Addendum #1

CHILD DEVELOPMENT LABORATORY

Southern University

Bid #9899

3. SHEET A2 – KEY NOTES

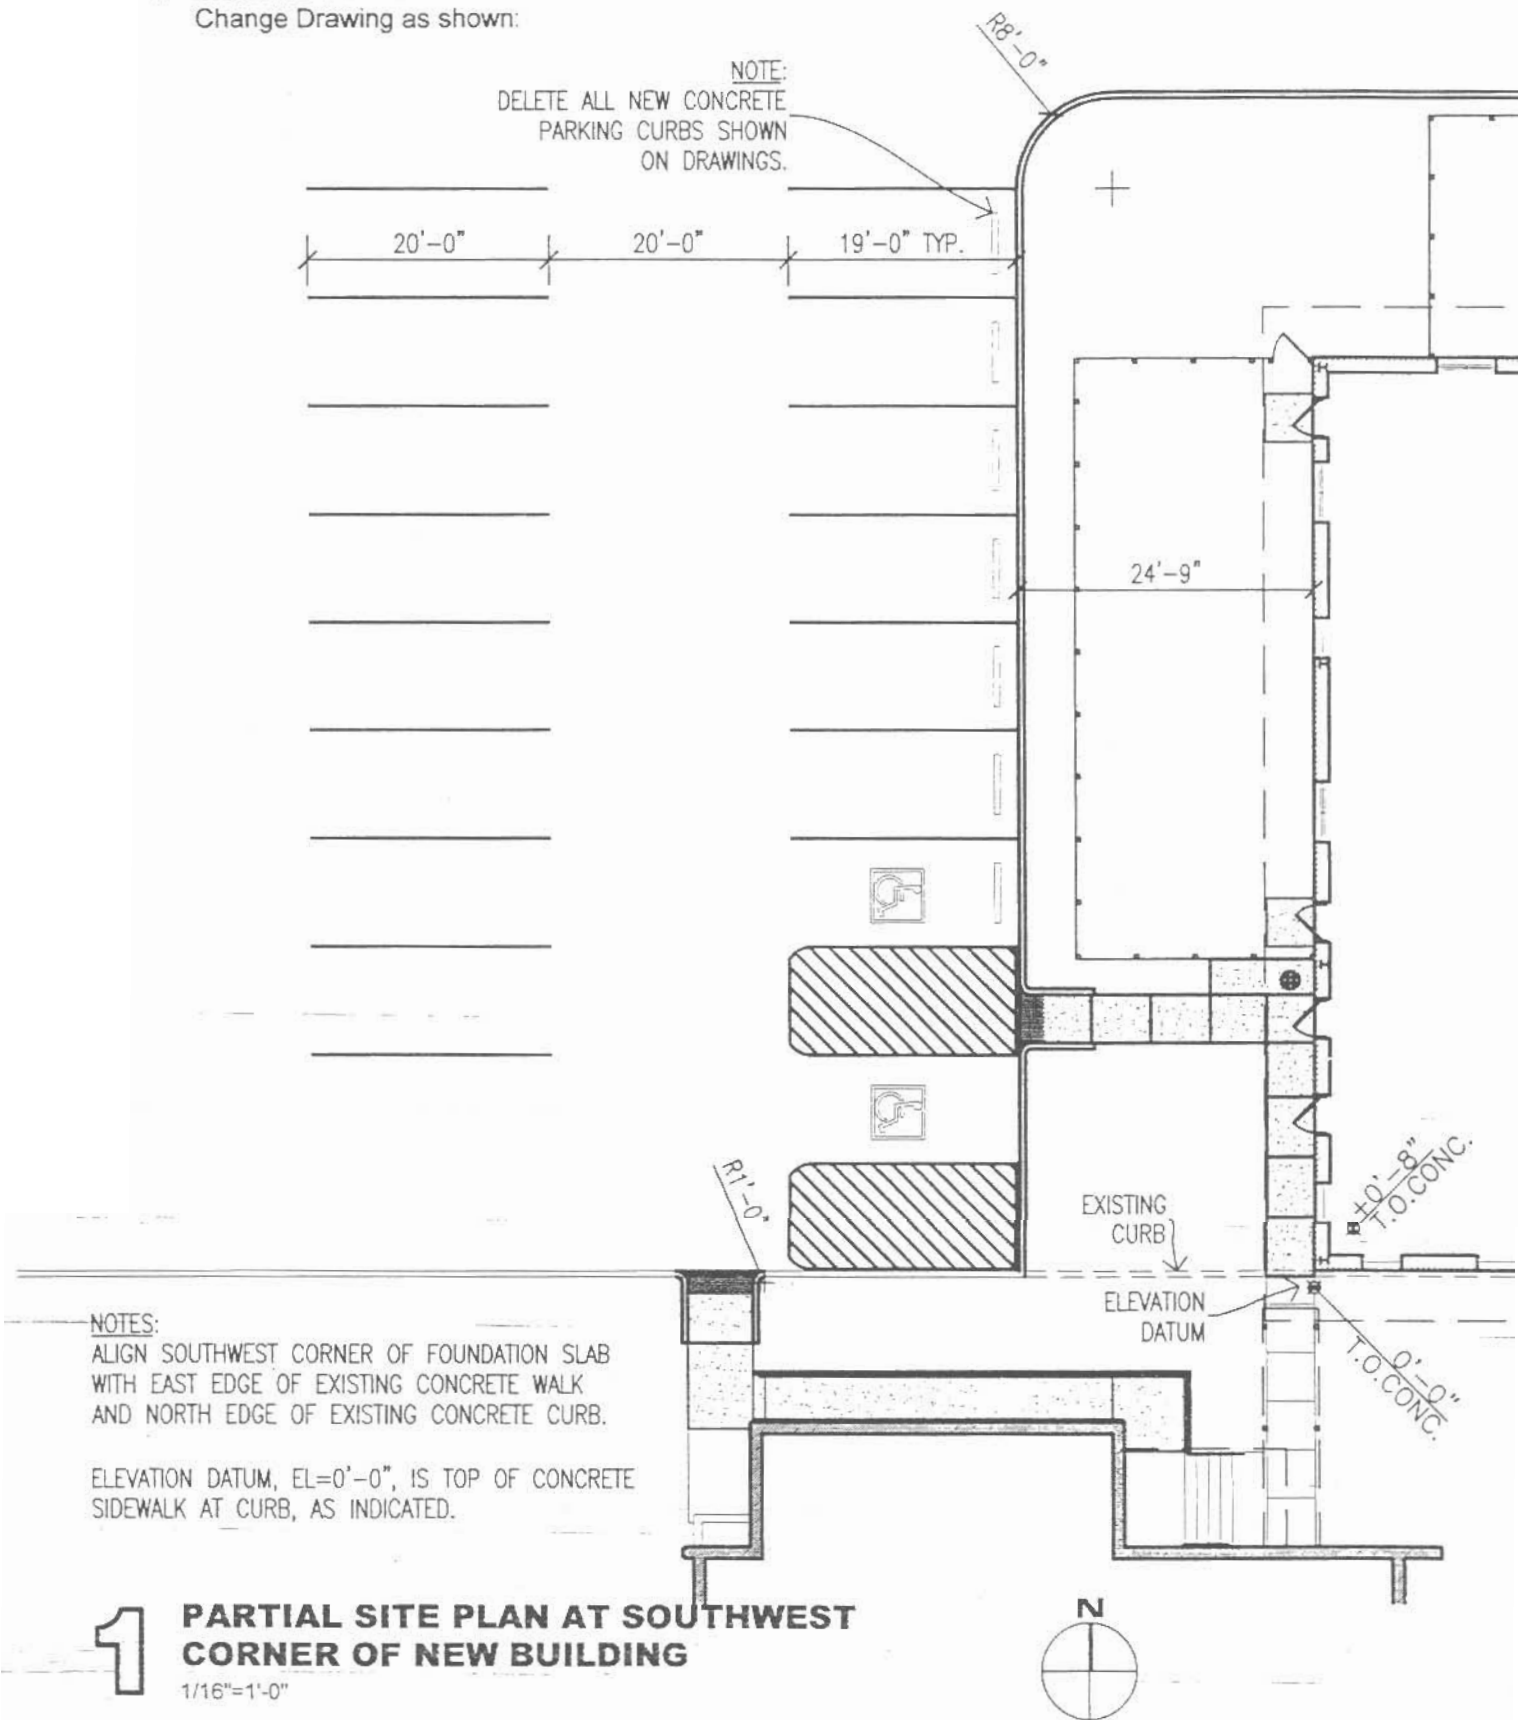
Change Key Notes as follows:

Key Note #1 – Change ... "asphalt" ... to ... "concrete"

Key Note #10 – Change Note to read:

*New concrete driveway. New concrete driveway shall be 6" thick w/ 6x6 6/6 wire mesh reinforcing w/ 6x6 concrete curbs w/ #4 hairpins, 12" long. **Alternate Bid.***

Key Note #14 – Change Note to read:

*Existing concrete curb to be removed by Contractor. **Base Bid.***

8. DRAWING 4A2 – RAMP SECTION

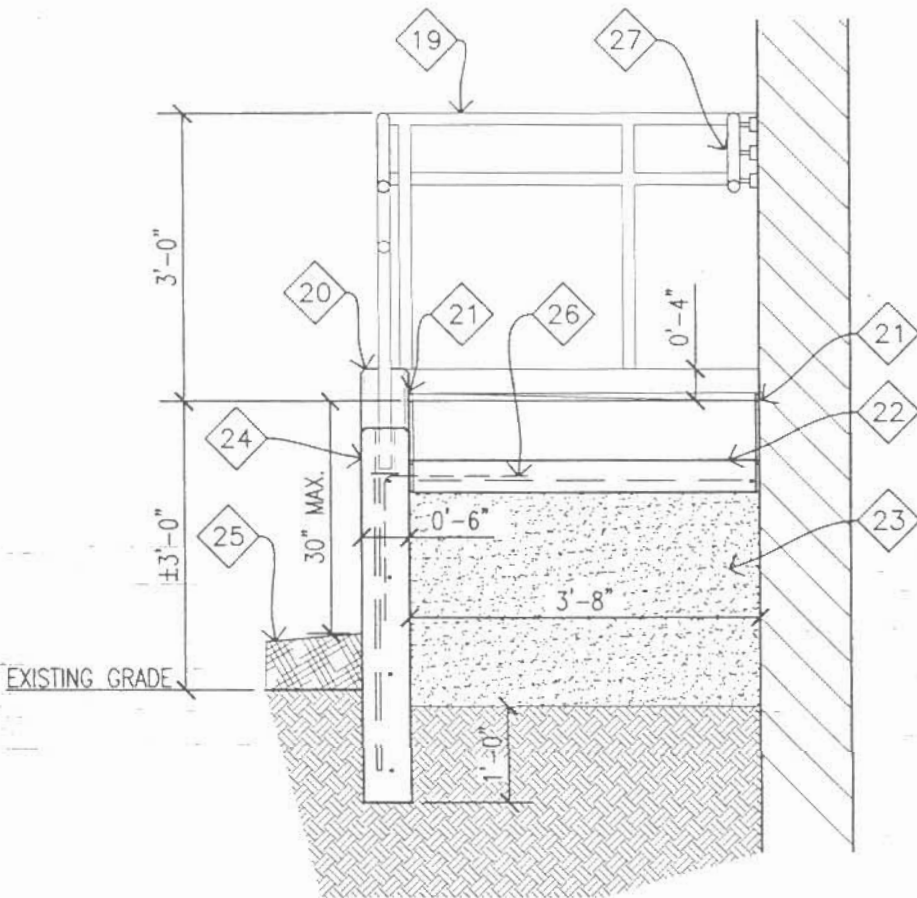
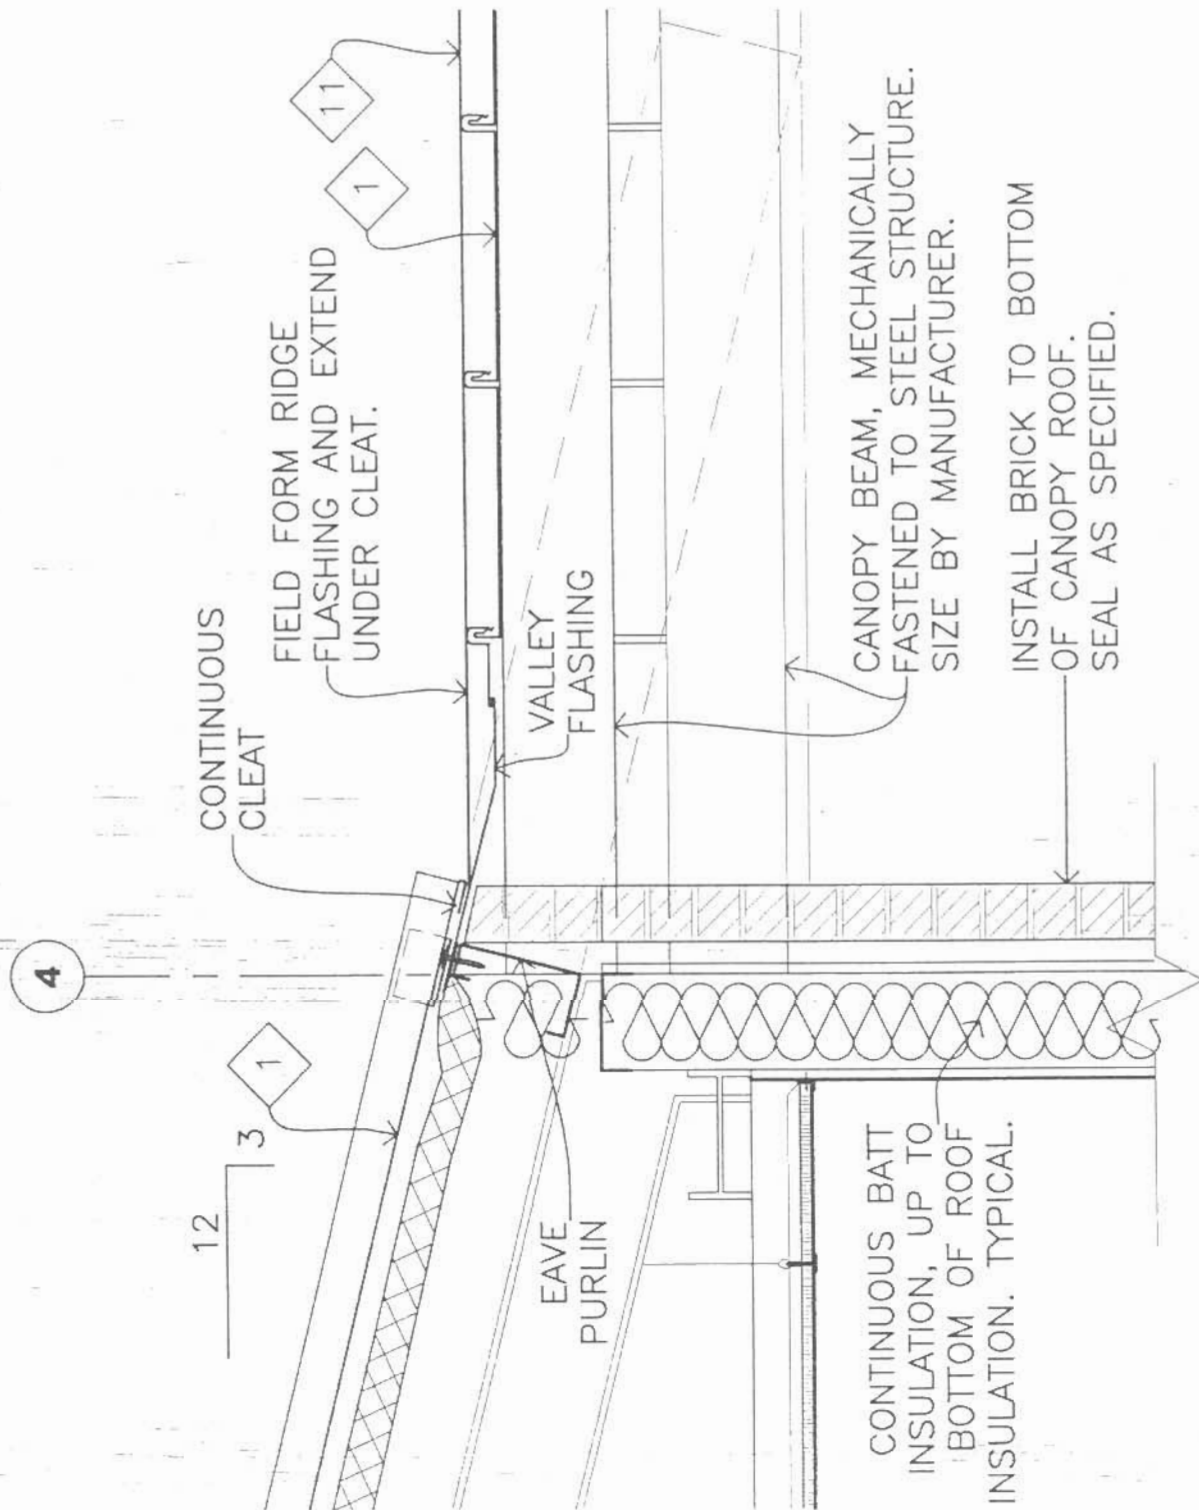
Substitute the following Drawing in lieu of the Drawing shown:

ADDED KEY NOTES

26. 18"X18" #4 REBARS, @ 24" CTR's.
27. NEW 1-1/2" GALVANIZED STEEL HANDRAIL ANCHORED TO EXISTING WALL WITH MASONRY ANCHORS.
